Access Compliance Report

Public Rights-of-Way

Intersection ID: 11422	Main Street: N_MCDOWELL_ST	Cross Street: PARKWOOD_AV	Location: SE
ADA ID: 81A8E7AEC3EE	Ramp Type: Perp	Initial Pass/Fail: Fail	Overall Compliance: No
Severity Score: 37.5			
Codes/Mitigation Info/Possible Solution		Field Measurements/Component Compliance

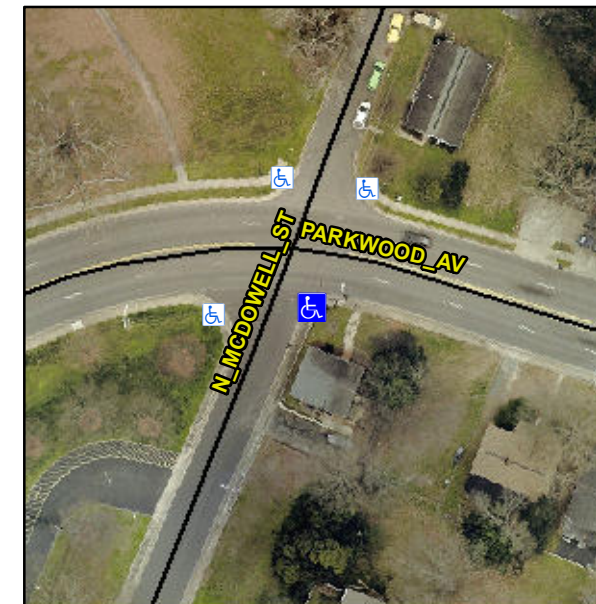
Not Found, R304.2.2, R304.5.3

Compliance	Description	Data	Compliance	Description	Data
N/A	Ramp Length (in)	53.0	No	Ramp Slope (%)	9.7
Yes	Ramp Width (in)	48.0	No	Ramp XSlope (%)	7.0
N/A	Flare Type LT	N/A	N/A	Flare Type RT	N/A
N/A	Flare Slope LT (%)	N/A	N/A	Flare Slope RT (%)	N/A
N/A	Flare Traversable LT?	N/A	N/A	Flare Traversable RT?	N/A
N/A	Landing Length (in)	N/A	N/A	DWS Provided?	N/A
N/A	Landing Width (in)	N/A	N/A	DWS Contrast?	N/A
N/A	Landing Slope (%)	N/A	N/A	DWS Length (in)	N/A
N/A	Landing X Slope (%)	N/A	N/A	DWS Full Width?	N/A
N/A	Landing Curb? (Y/N)	N/A	N/A	DWS Offset (in)	N/A
N/A	Shared Landing?	N/A			
N/A	Gutter Ponding?	N/A	N/A	Gutter Slope (%)	N/A
N/A	Gutter Lip Ht (in)	N/A	N/A	Gutter X Slope (%)	N/A
N/A	Painted X Walk1?	No	N/A	Painted X Walk2?	N/A
	X Walk 1 Direction	To W		X Walk 2 Direction	N/A
N/A	X Walk 1 Width (in)	N/A	N/A	X Walk 2 Width (in)	N/A
	X Walk 1 Slope (%)	4.0		X Walk 2 Slope (%)	N/A
	X Walk 1 X Slope (%)	3.2		X Walk 2 X Slope (%)	N/A

Remove & Replace Entire Ramp.
